ADDENDA TO CONTRACT DOCUMENTS VOLUME NO. 3

CONTRACT 876-HP

GEOMEMBRANE CAPPING AND
GAS COLLECTION SYSTEM
PELHAM BAY LANDFILL REMEDIATION
HUNTS POINT DRAINAGE AREA

ADDENDA TO CONTRACT DOCUMENTS - VOLUME NO. 3 - MAY 1994

MINIMUM LOAD DIAGRAM FOR NON-WATER TIGHT SHEETING DESIGN

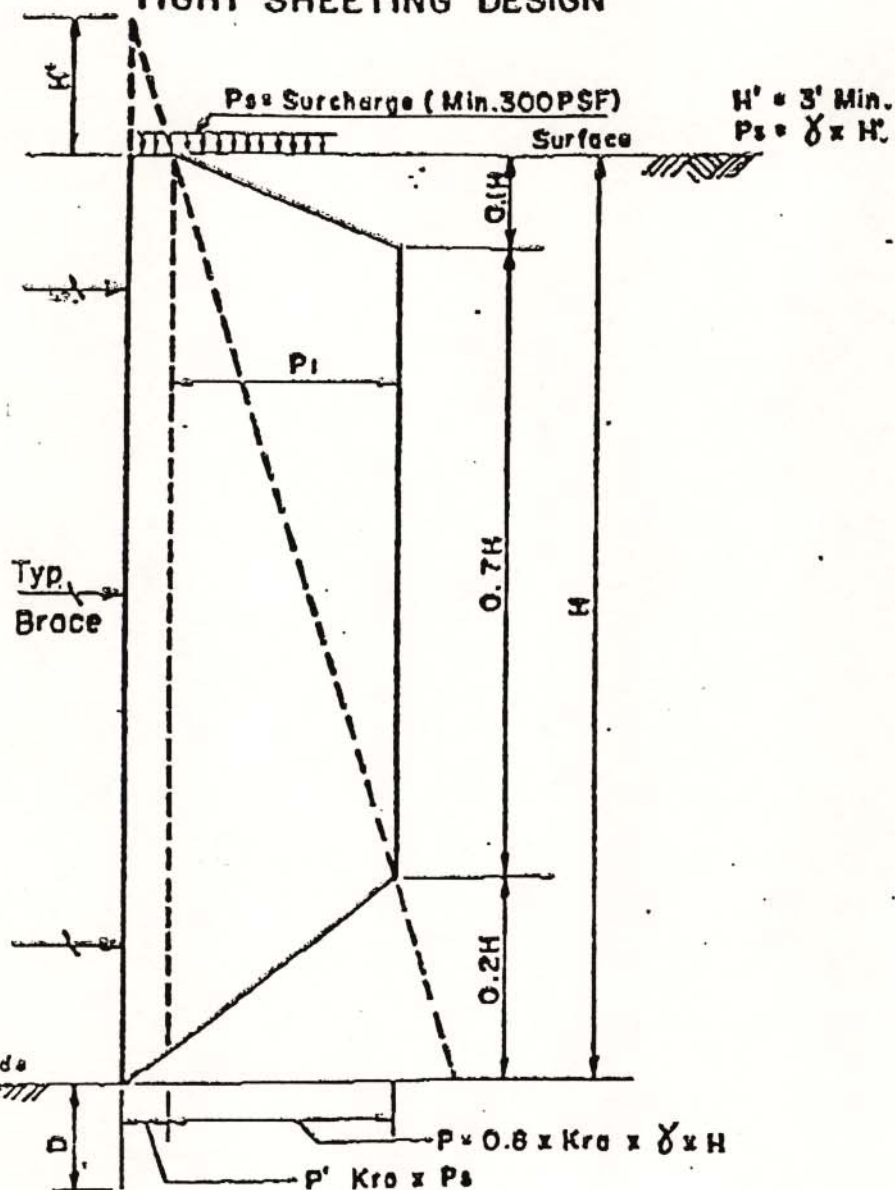
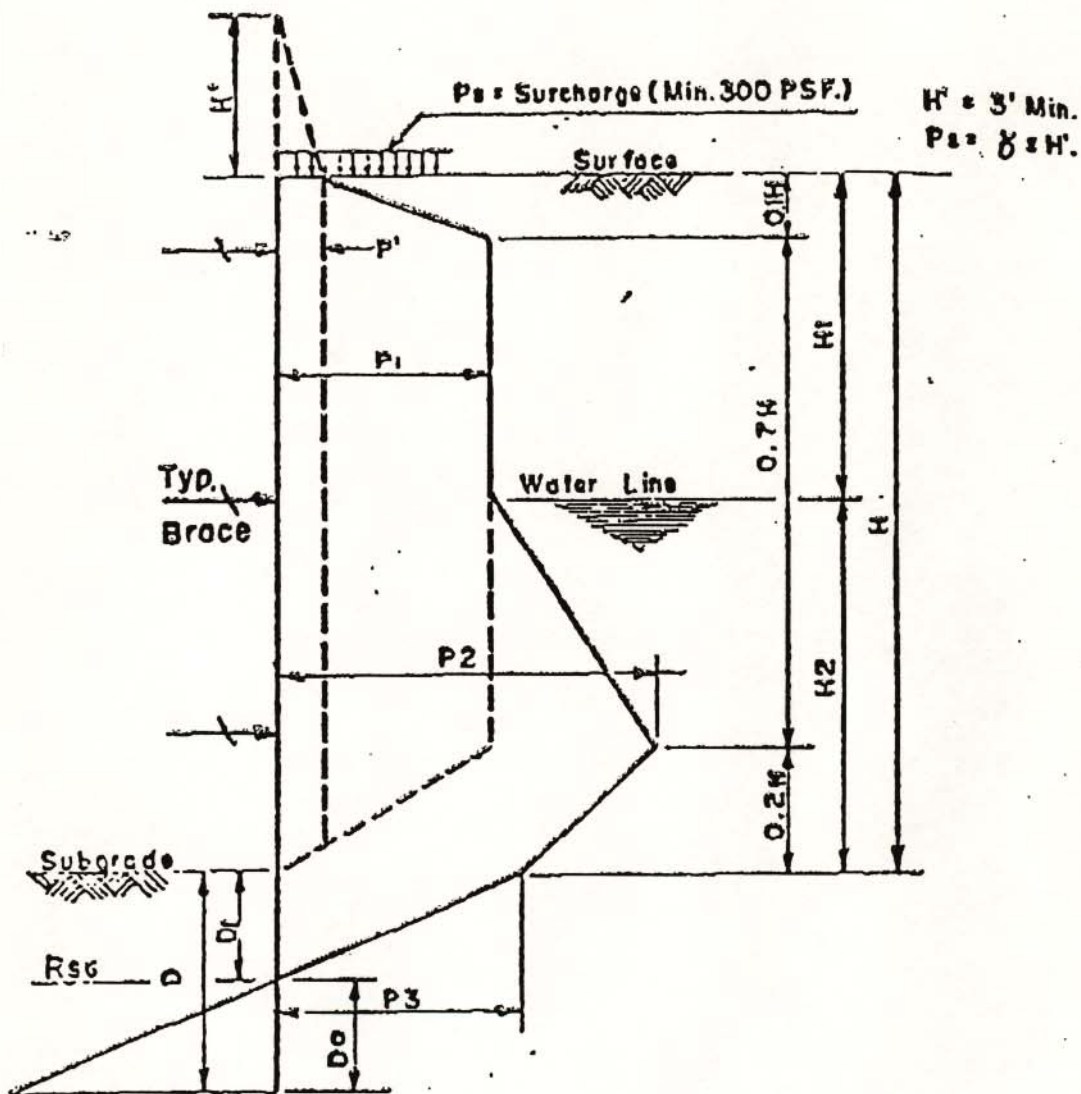
1. Page 628 of the Specifications, paragraph 1.8 - Open Excavations... Add the following paragraphs:
 - C. The sheeting and bracing working drawings submitted by the Contractor shall include, but not be limited to, the following: the density of the soil, the internal angle of friction of the soil, the stress grade and type of lumber, the allowable stresses, and sequence of construction operation where required.
 - D. In designing the sheeting, the Contractor's engineer shall take note of the following minimum load diagram requirements of the Department of Environmental Protection, attached.

ADDENDUM NO. 33 - Contract Drawing C.9

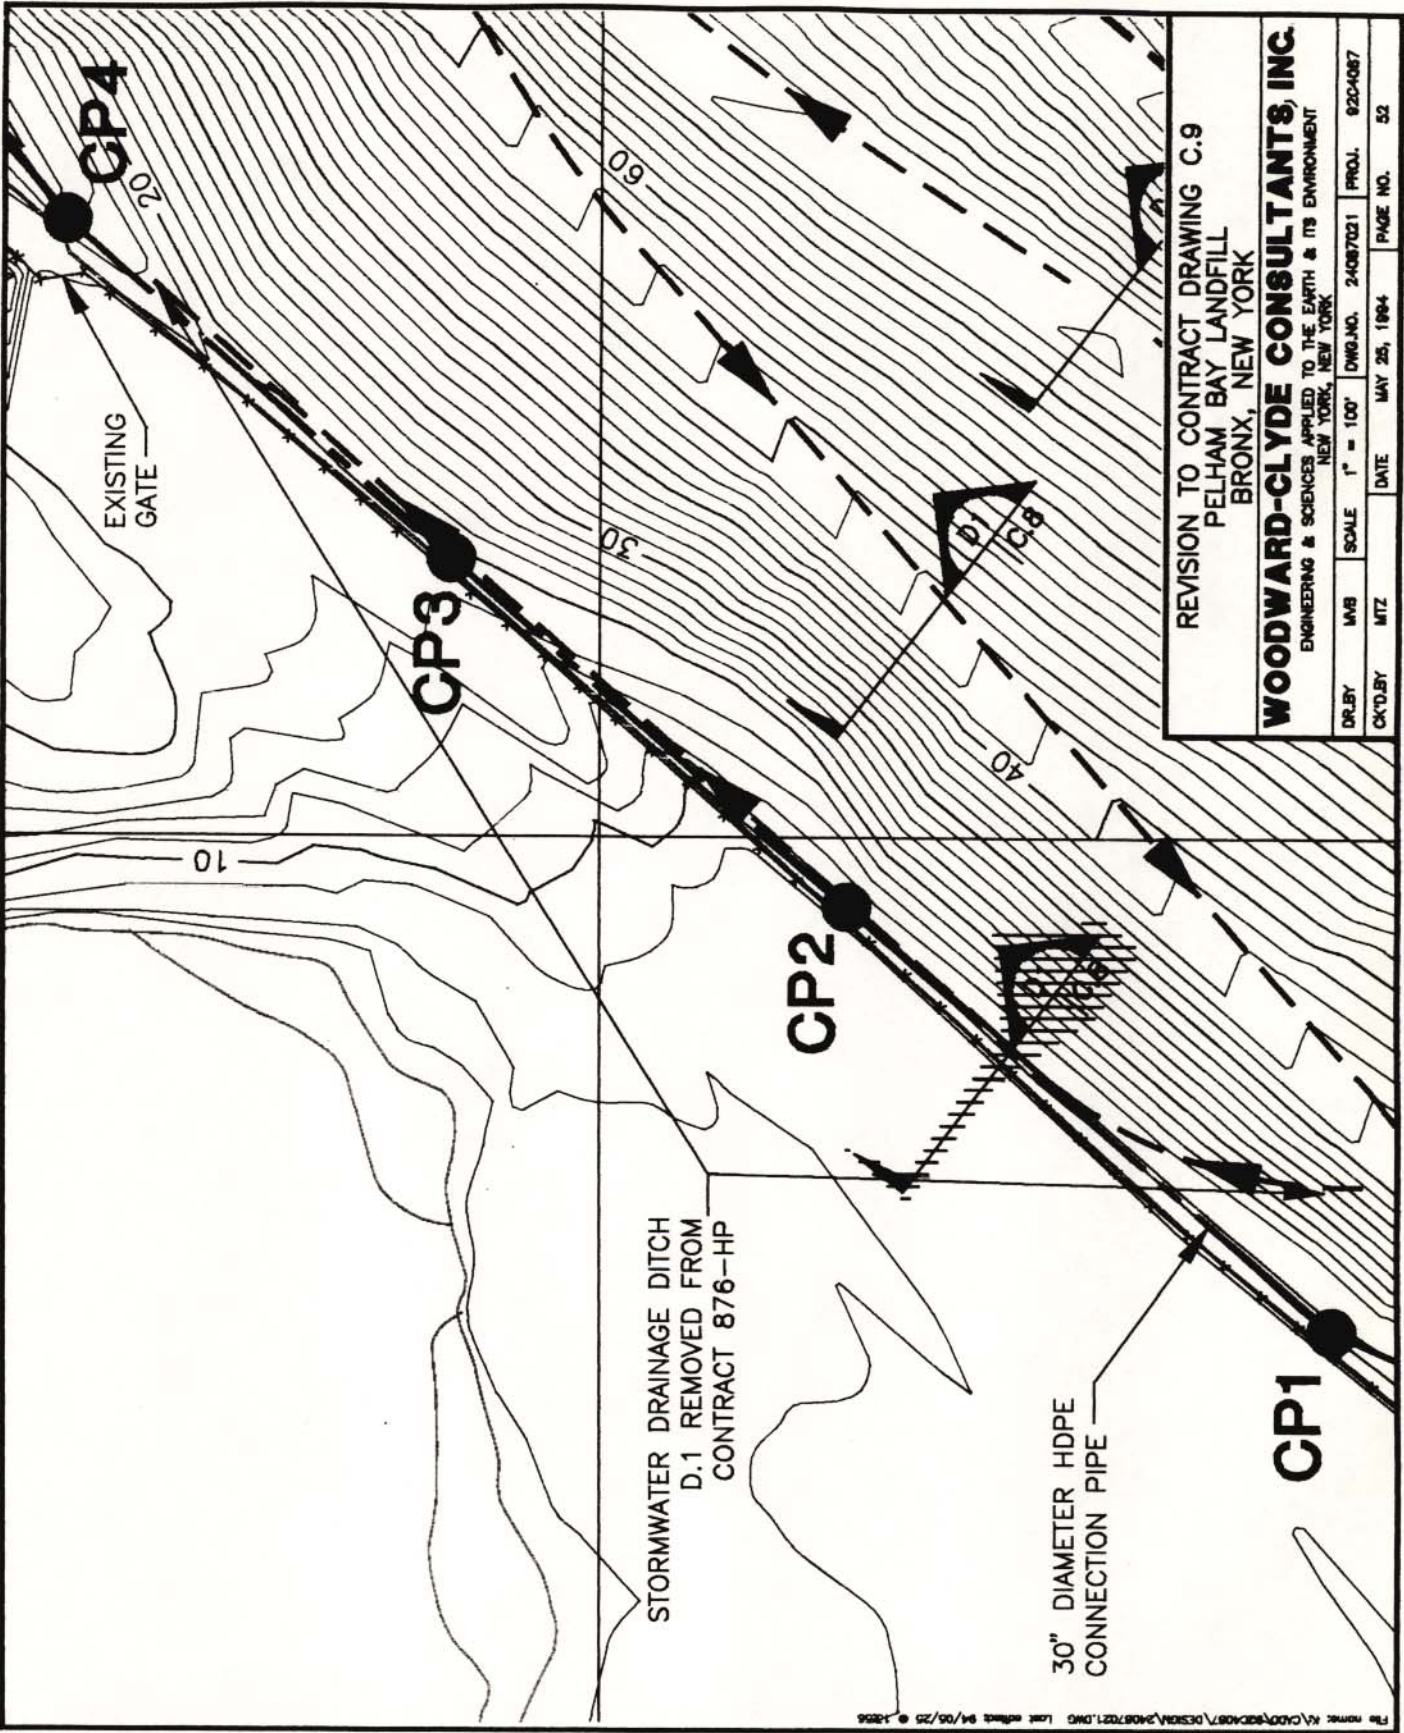
1. Revise Contract Drawing C.9 as described below and shown on the drawing attached on the following page.
 - A. Remove the stormwater drainage ditch shown adjacent to Pelham Bridge Road along the northwest boundary of the landfill, extending from manhole CP1 to CP4.

REVISION TO CONTRACT DRAWING C.16
PELHAM BAY LANDFILL, BRONX, NEW YORK

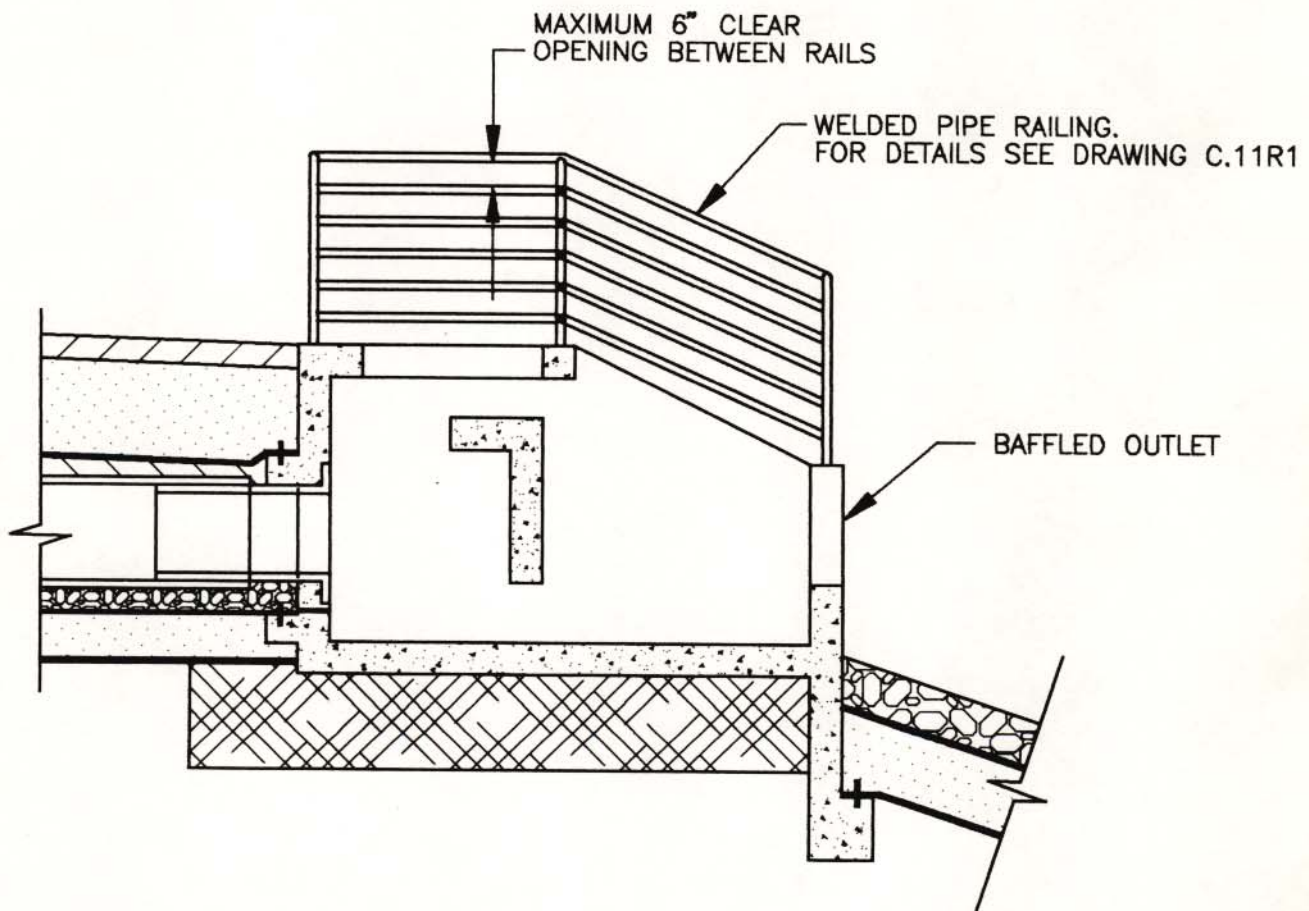
1. Replace the Welded Pipe Railing details for Baffled Outlets BO1, BO2, BO3, and BO4 with the revised version, attached on the following page.

REVISED DETAIL 4			
CONTRACT DRAWING C.17			
PELHAM BAY LANDFILL, BRONX, NEW YORK			
WOODWARD-CLYDE CONSULTANTS, INC.			
ENGINEERING & SCIENCES APPLIED TO THE EARTH & ITS ENVIRONMENT NEW YORK, NEW YORK			
DR. BY	MVB	SCALE 1-1/2" = 1'-0"	DWG. NO. 24087024
CK'D. BY	MTZ	DATE MAY 25, 1994	PAGE NO. 80

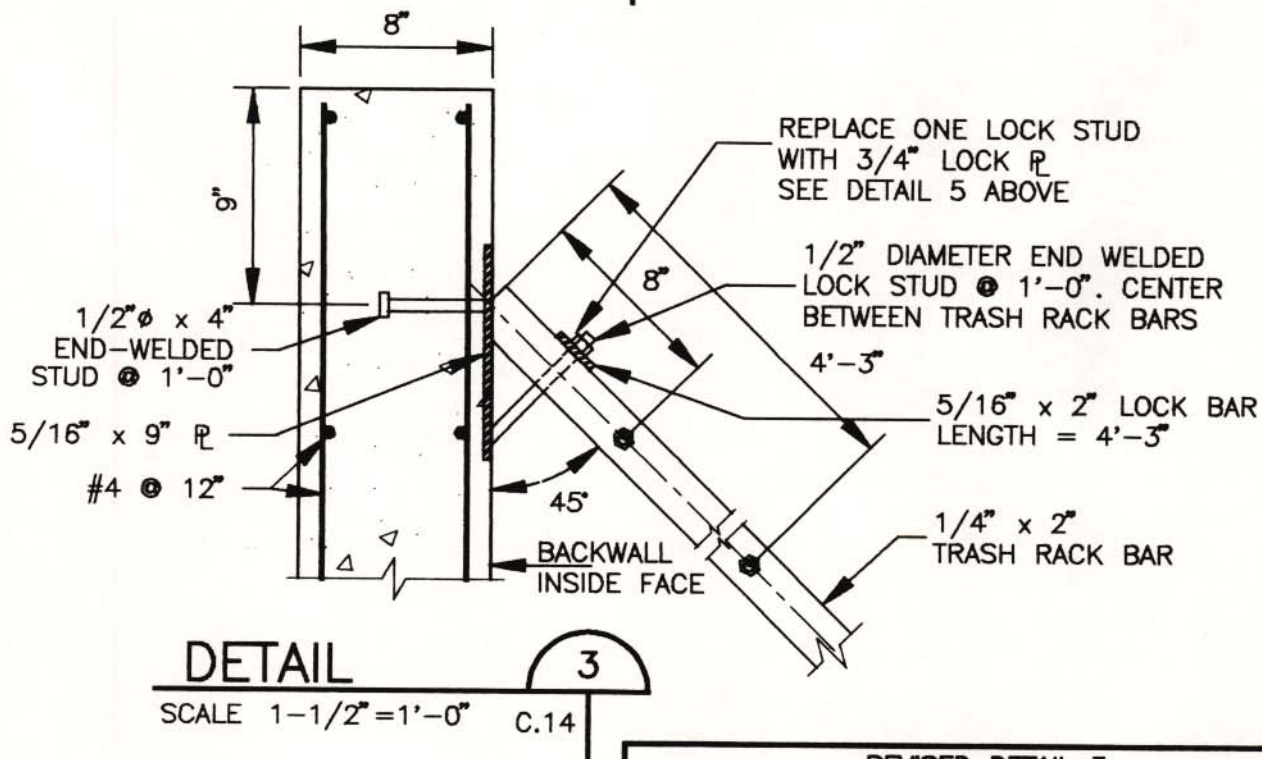
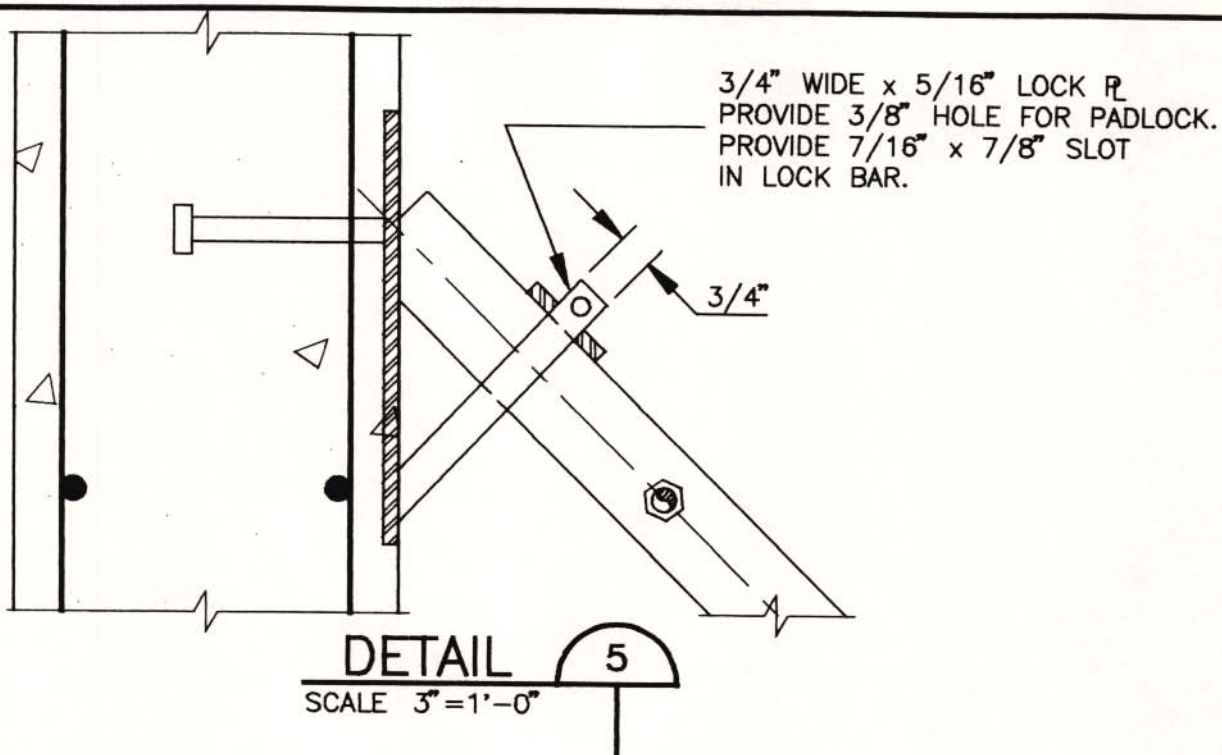
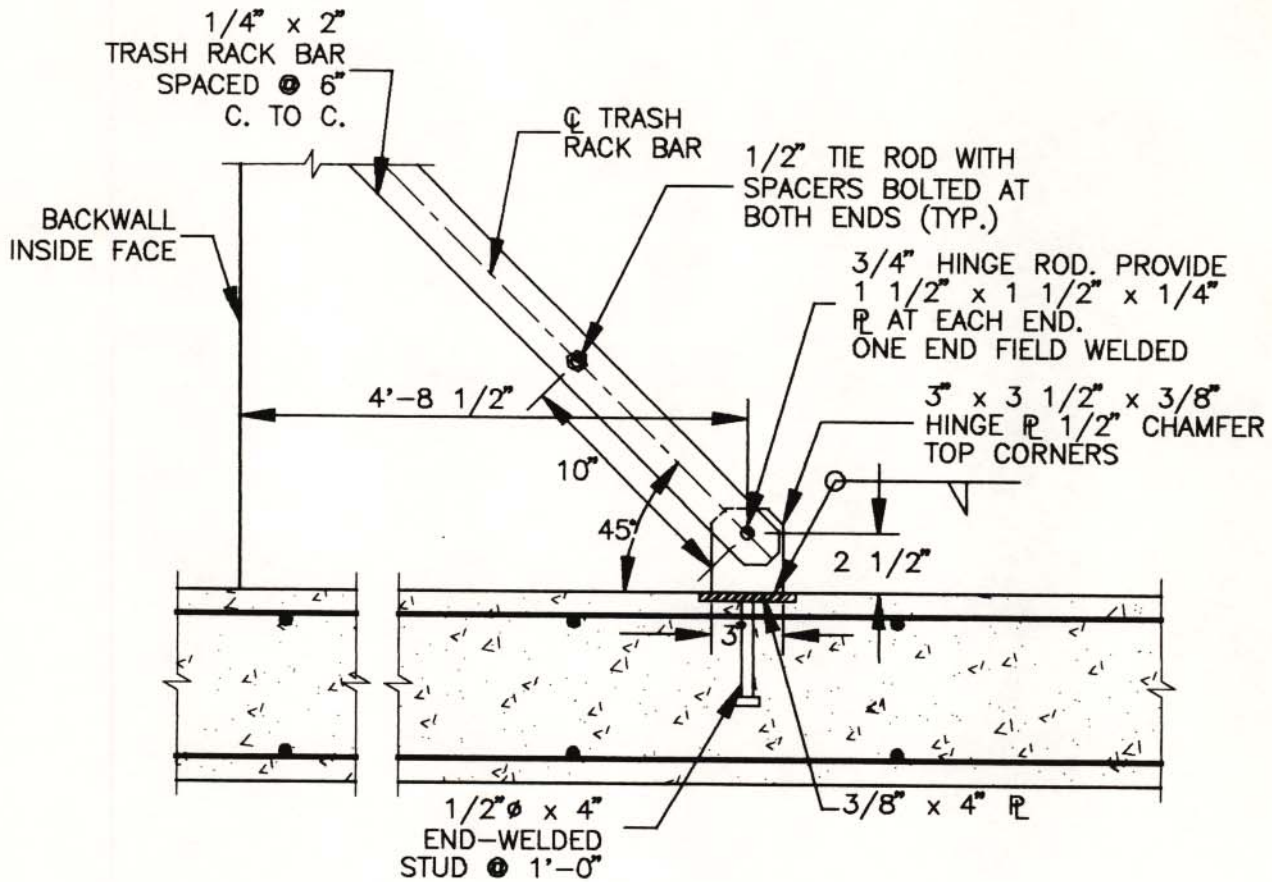
1. Replace Detail 3 and Detail 4 with the revised versions, attached on the following pages.
2. Delete Lighting Plan - 5 from Contract 876-HP.

1. CONTRACTOR SHALL PROVIDE DISCONTINUOUS HINGE ROD FOR TRASH RACK OR POUR STRUCTURE SIDEWALLS AFTER INSTALLATION OF TRASH RACK TO AVOID CONFLICT.

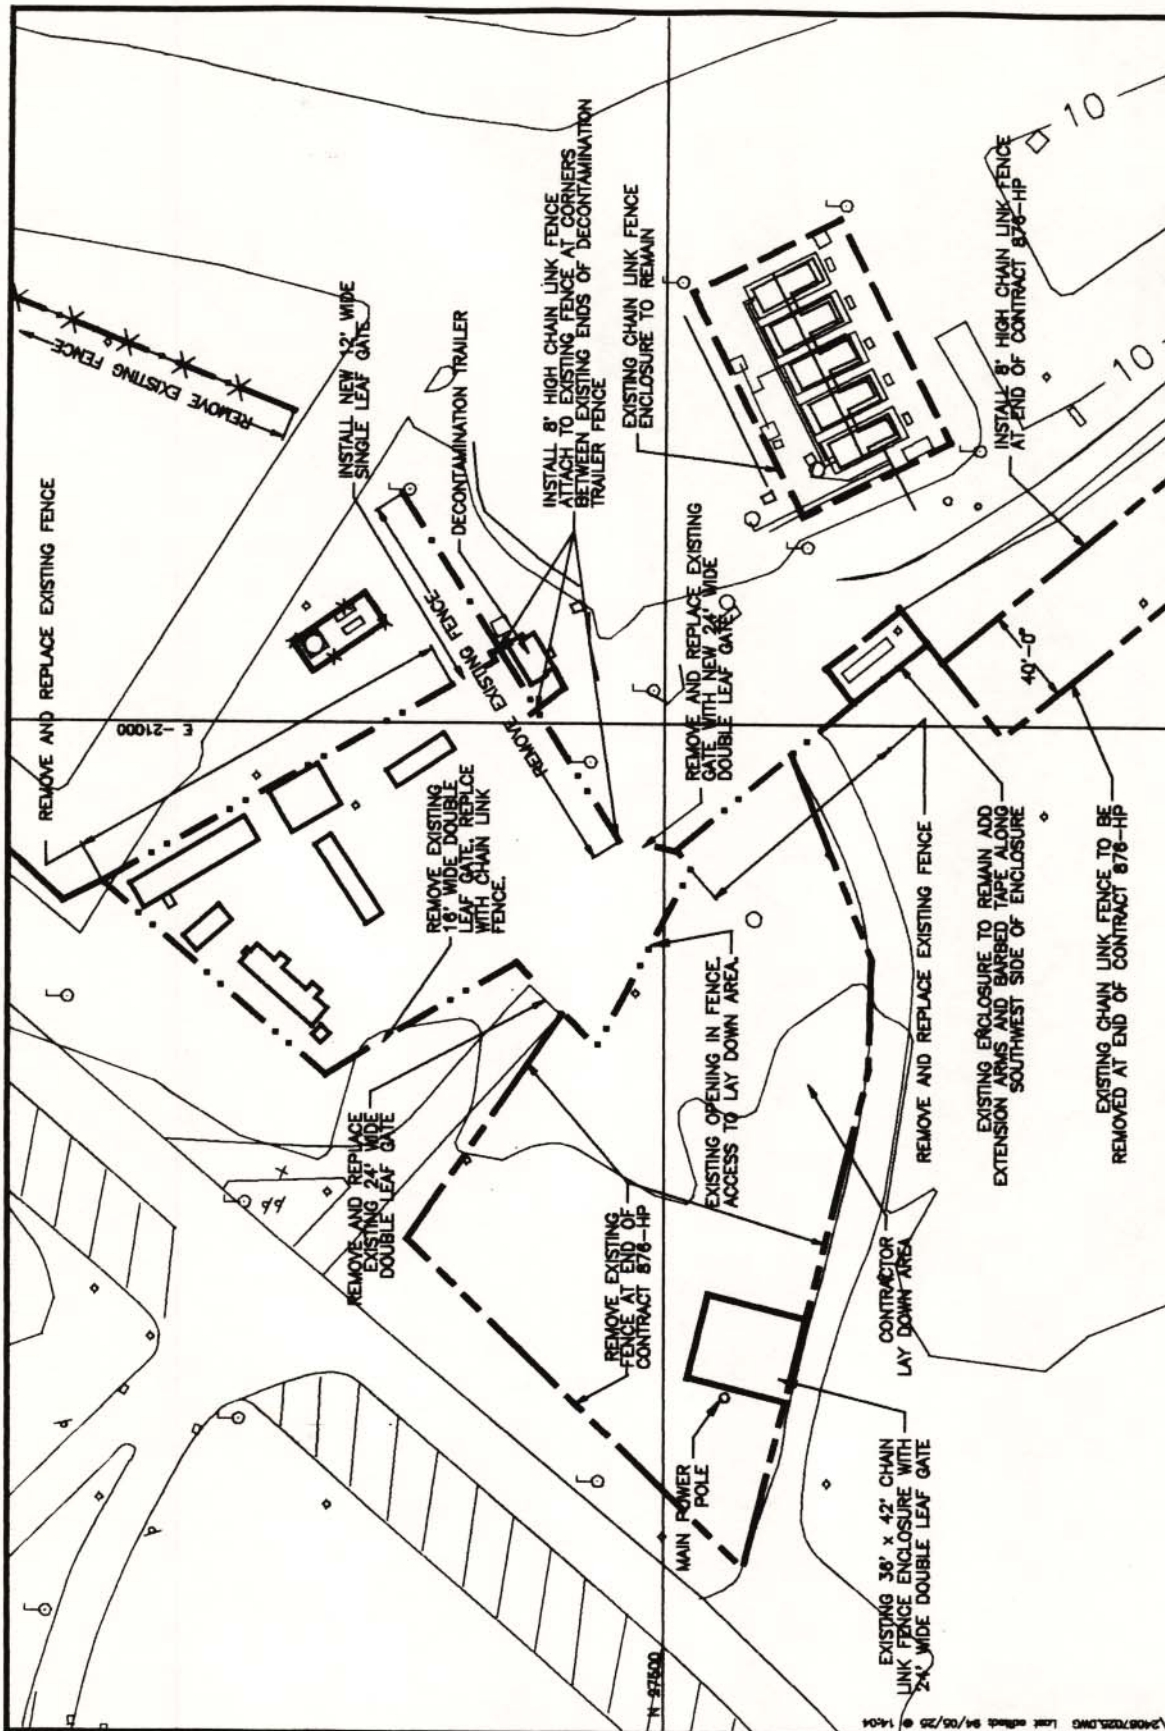
1. Replace Trailer Area Fence Plan with the revised version, attached on the following page. Revision made to this Plan is described below:
 - A. Existing fence condition around the contractor's lay-down area has been modified.
